Issuing Entity: Wadkins Expo Wheel, Inc. 11501 Sherwood Road Upper Falls, Maryland 21156 443-463-8016 443-463-1637 <a href="mailto:wadkinsexpowheel@yahoo.com">wadkinsexpowheel@yahoo.com</a>	Bulletin No.: 2013-1
		Release Date: January 3, 2014
		Effective Date: January 3, 2014
		Supersedes: N/A
		Completion Date: Immediate testing to be completed before resuming public operation
		Page: 1 of 5

# SAFETY ALERT

Ride Manufacturer: Wadkins Expo Wheel, Inc. Expo Wheels, LLC Childress Manufacturing	Affected Production Dates: 1996-2009
Ride Name: Expo Wheel	Affected Serial Nos.: All before 2010
Model Number: All with bronze-bushing axles	
<p><b>Abstract Of Issue:</b> All Expo Wheels with original bronze-bushing axles must be ultrasonic tested. Cracks may occur next to welds behind flange or behind the 8 bolts on main axle.</p> <p><b>Reason For Release:</b> Wadkins Expo Wheel, Inc., has been made aware of an Expo Wheel on which the axle has cracked. The effect may occur in or out of plain sight. If this occurs, do not operate the Expo Wheel.</p> <p><b>WARNING: FAILURE TO COMPLY WITH SAFETY ALERT CAN RESULT IN INJURY TO PASSENGERS OR OPERATORS.</b></p> <p>Wadkins Expo Wheel, Inc., issues no

Diagram 1 –

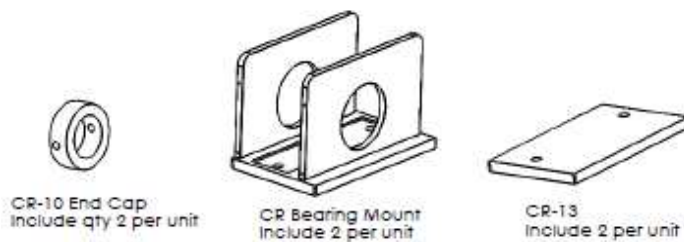
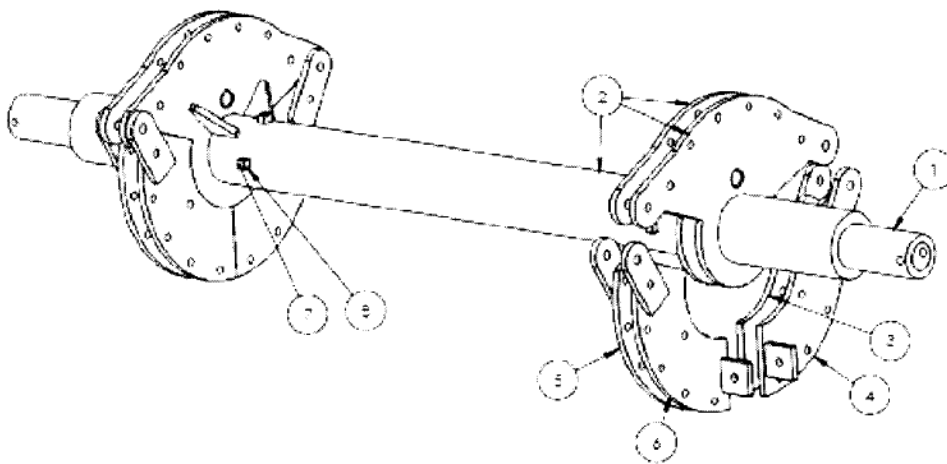
Each Expo Wheel with an original bronze-bushing axle must have the entire axle ultrasonic tested immediately by an outside, licensed firm. The main axle is identified as Item No. 1 in Diagram 1.

<p><b>Action To Be Taken:</b> All Expo Wheels with original bronze-bushing axles must be ultrasonic tested immediately. Thereafter, ultrasonic testing should be done annually or</p>

Diagram 2 –

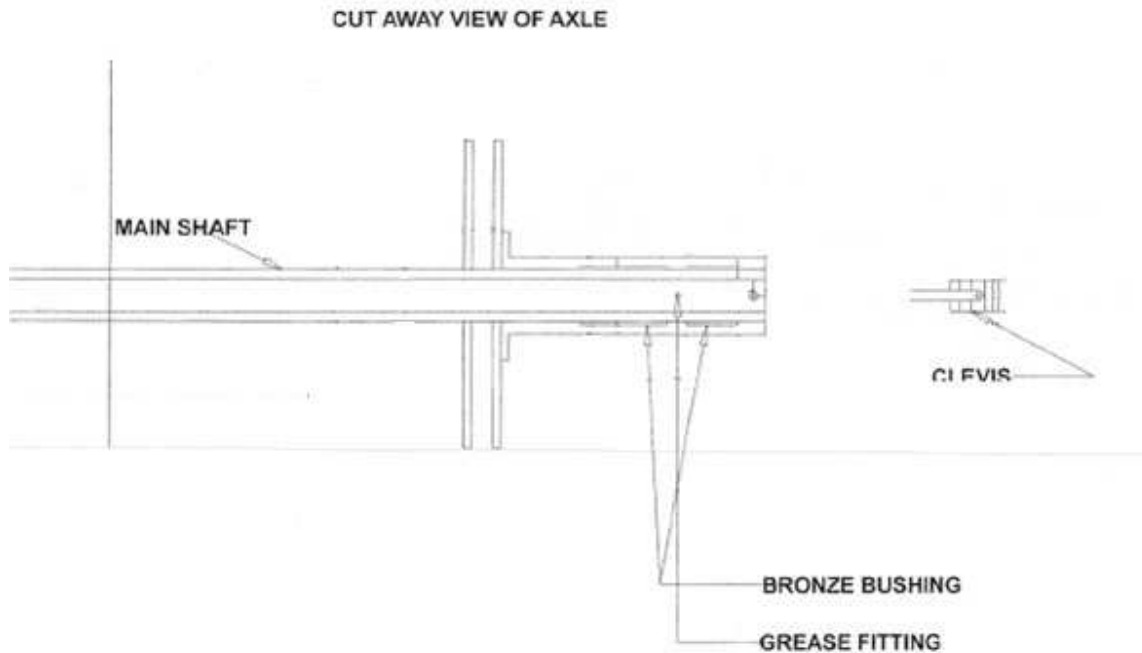
Diagram 2 shows the location of the bronze bushings.

Diagram 3 –

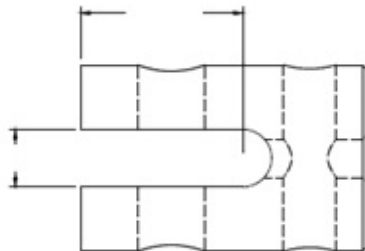
If the axle *passes* the ultrasonic testing, install a safety cable through the center of the axle. Attachment of the clevis cable is shown in diagram 3.

Diagram 4 –

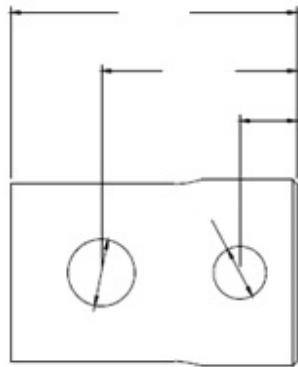
Clevis pin material is shown in diagram 4.
